BRIDGEPORT ROAD SAFETY AUDIT

ROUTE 1: SHERIDAN STREET TO BRUCE AVENUE

JANUARY 2022

Exhibit 20: Crosswalk at Willow Street

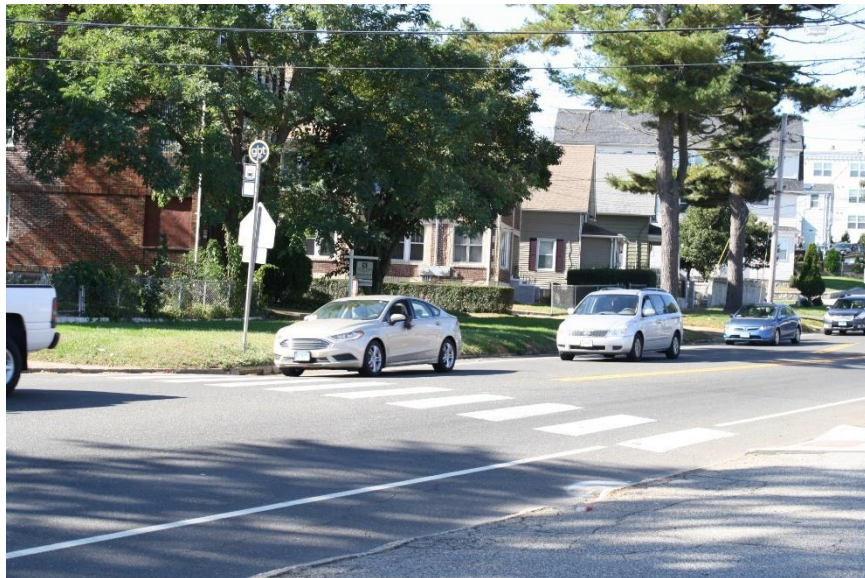
- Missing pedestrian sign in the Route 1 southbound direction (was knocked down at time of RSA).
- Curb ramp missing at southern curb.
- Damaged bus shelter at the westbound bus stop.
- Crossing was observed to be very difficult during RSA assessment period. There are many dead trees and hanging limbs near the intersection. See Exhibit 20.

BOSTON AVENUE (US ROUTE 1)
EXHIBIT 32: STUDY AREA RECOMMENDATIONS

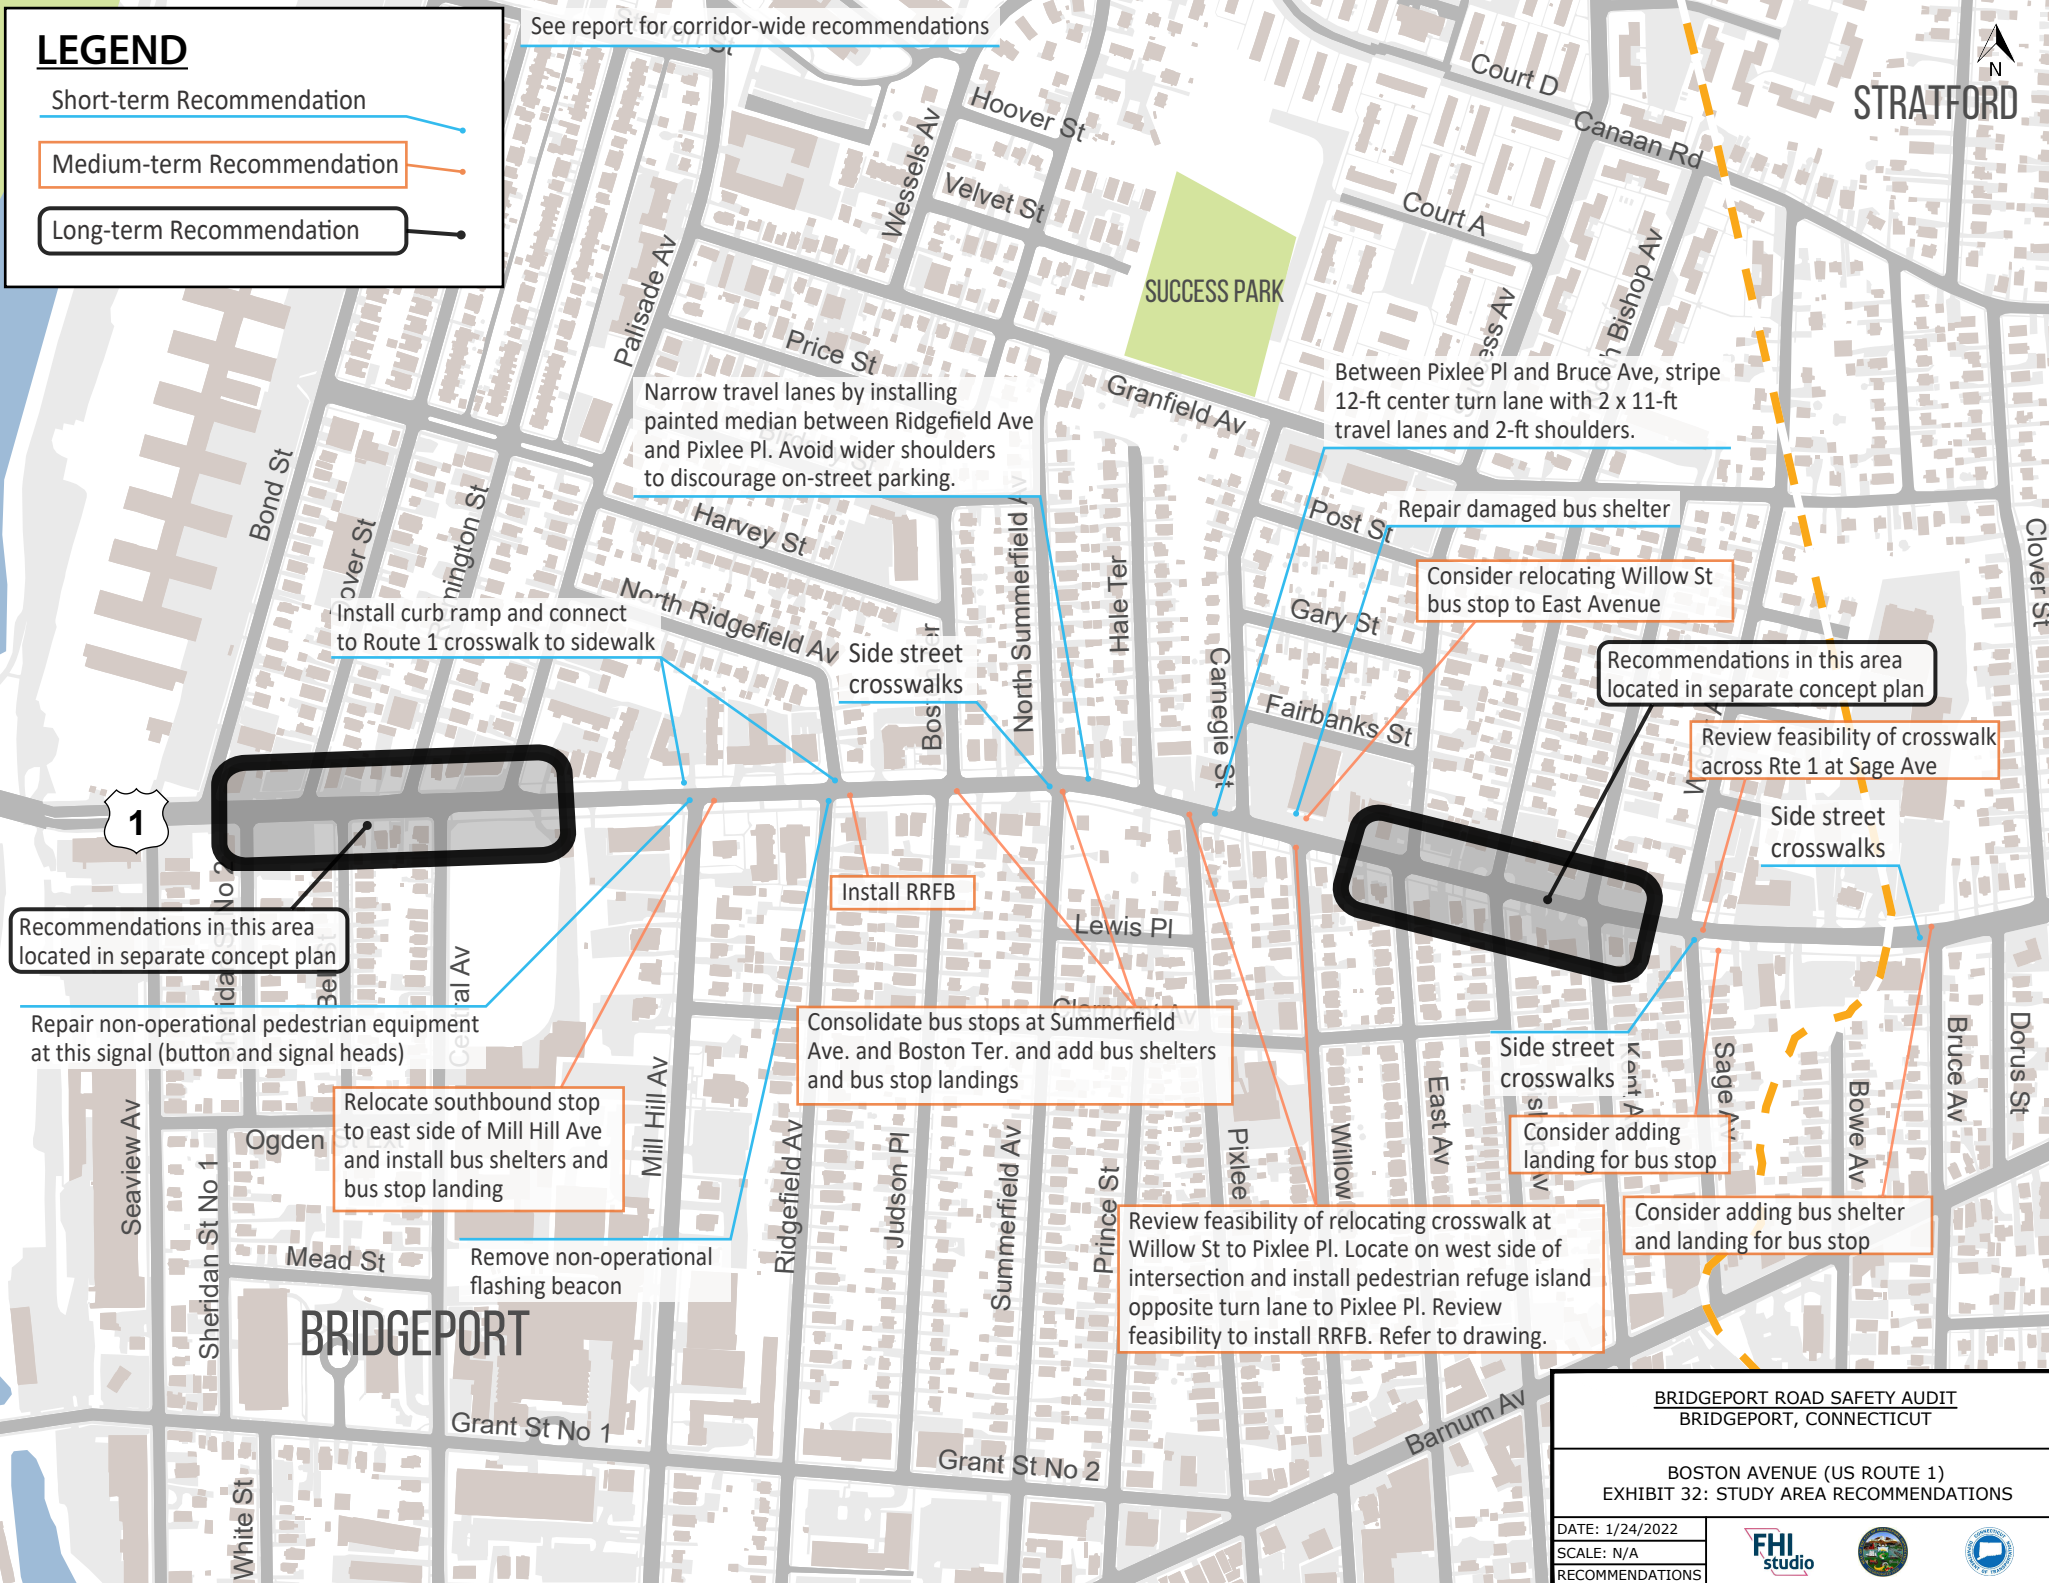
Narrow travel lanes by installing painted median between Ridgefield Ave and Pixlee Pl. Avoid wider shoulders to discourage on-street parking.

Between Pixlee Pl and Bruce Ave, stripe 12-ft center turn lane with 2 x 11-ft travel lanes and 2-ft shoulders.

Install curb ramp and connect to Route 1 crosswalk to sidewalk

Repair damaged bus shelter

Consider relocating Willow St bus stop to East Avenue

Review feasibility of crosswalk across Rte 1 at Sage Ave

Repair non-operational pedestrian equipment at this signal (button and signal heads)

Install RRFB

Consolidate bus stops at Summerfield Ave. and Boston Ter. and add bus shelters and bus stop landings

Relocate southbound stop to east side of Mill Hill Ave and install bus shelters and bus stop landing

Remove non-operational flashing beacon

Review feasibility of relocating crosswalk at Willow St to Pixlee Pl. Locate on west side of intersection and install pedestrian refuge island opposite turn lane to Pixlee Pl. Review feasibility to install RRFB. Refer to drawing.

**BOSTON AVENUE (US ROUTE 1)
EAST AVE - WEBER ST CONCEPT PLAN**

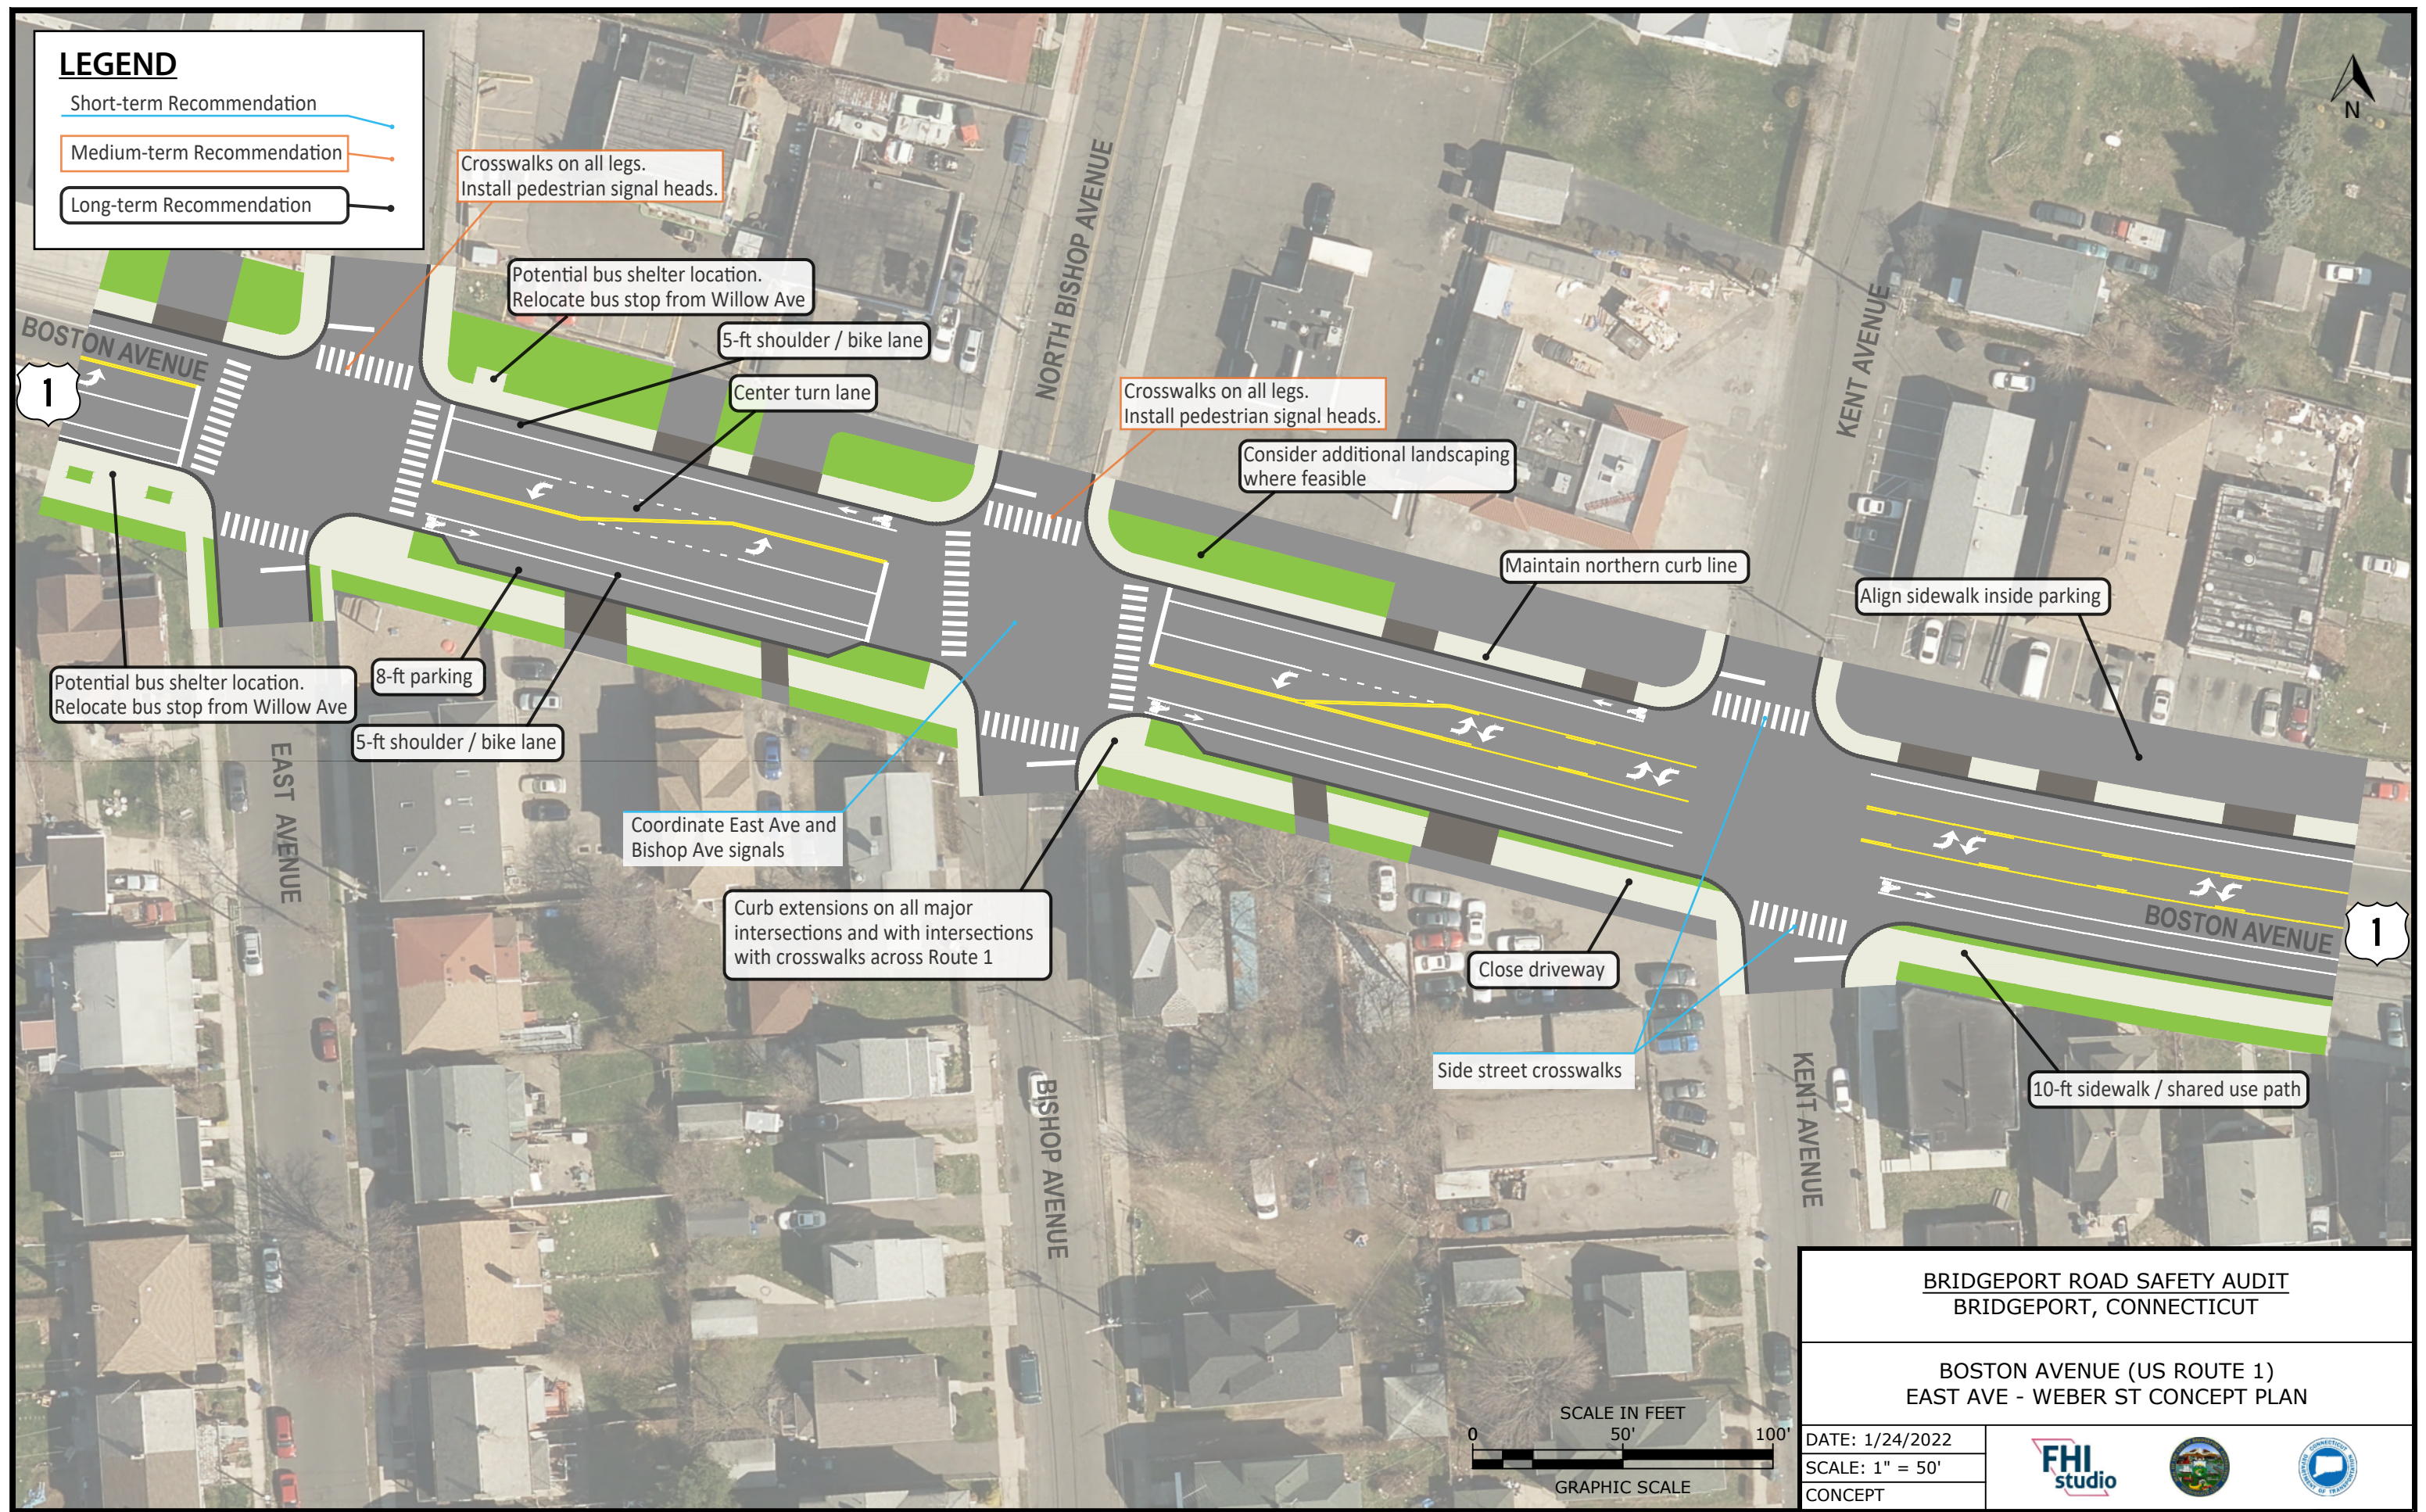
Crosswalks on all legs.
Install pedestrian signal heads.

Potential bus shelter location.
Relocate bus stop from Willow Ave

5-ft shoulder / bike lane

Center turn lane

Crosswalks on all legs.
Install pedestrian signal heads.

Maintain northern curb line

Align sidewalk inside parking

8-ft parking

Coordinate East Ave and
Bishop Ave signals

Curb extensions on all major
intersections and with intersections
with crosswalks across Route 1

Close driveway

10-ft sidewalk / shared use path
